Authors' Response to Reviews of

Arctic sea surface height maps from multi-altimeter combination

P. Prandi et al.

Earth System Science Data, 10.5194/essd-2021-123

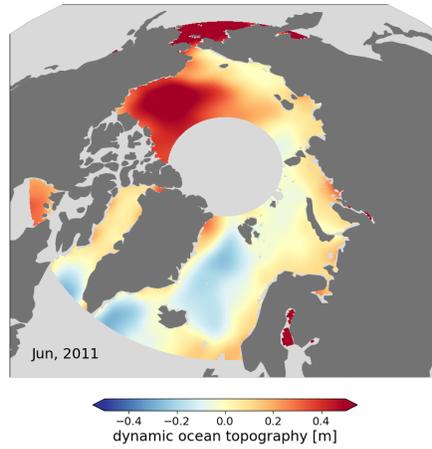
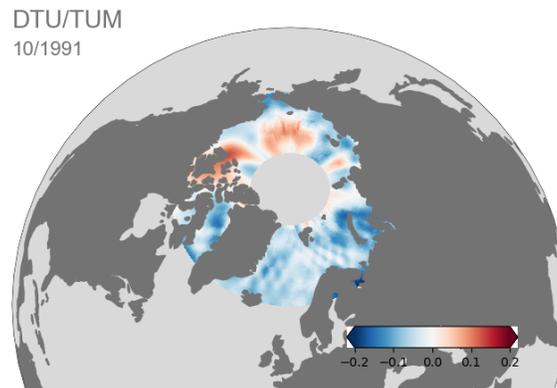
RC: ***L26: 1000km spatial resolution. This seems not correct! the whole Arctic is just about 4500 km wide***

AR: 1000km resolution is a bit exaggerated, and this was changed in the revised version to 'several hundred kilometer'. But while the grids the products are interpolated on might be 'high' resolution (down to about 25 km). The effective product resolution is certainly much lower than that. As an example, I've included below two snapshots of the Armitage et al. and Rose et al. datasets. From these snapshots, it is clear that the effective resolution of these datasets is lower than the grid resolution they are interpolated onto.

Figure 5: comparisons to the Prudhoe Bay record used in this paper

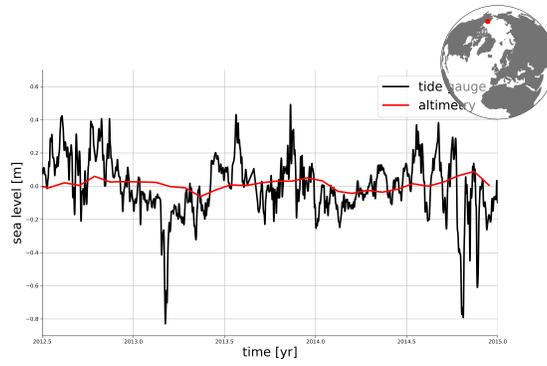
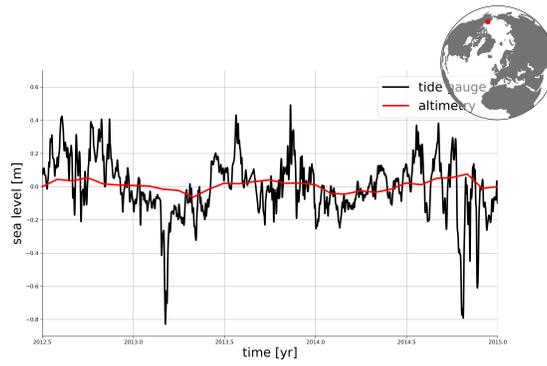
RC: L:257-261: *How are your results compared to other studies? Both (Armitage et al., 2016; Rose et al., 2019) have better single mission correlation at Prudhoe Bay.*

AR: I don't really want to get into comparing correlations with tide gauges across papers. There are many details that can impact the correlations. Among them:

- both Armitage et al. and Rose et al. used monthly PSMSL data, while we use hourly GLOSS/CLIVAR data,
- Armitage et al. apply a 300km filter on altimetry before selecting the closest grid cell, 350 km for Rose et al., while we are at 50 and 150 km,
- temporal periods do not overlap,

We did however perform a quick comparison between our hourly tide gauges time series and CPOM and DTU datasets. The resulting time series at Prudhoe Bay are included in this response as figure 5

Figure 8: SL variance levels

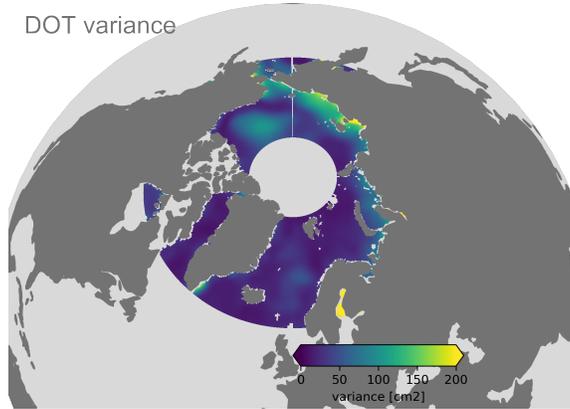
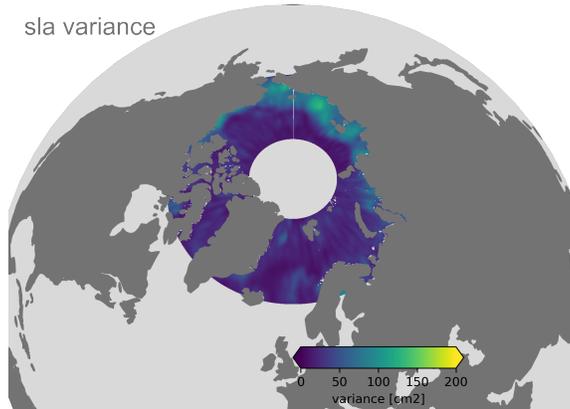
RC: *L222: "The variance distribution..." I can't find a plot or a deeper comparison between the existing datasets and the proposed one.*

AR: We didn't include plots from other datasets, and I'm not sure this necessary for the paper. Since the open discussion will remain visible, I'll include them here (figure 8). Please be aware that these are estimated on different time spans.
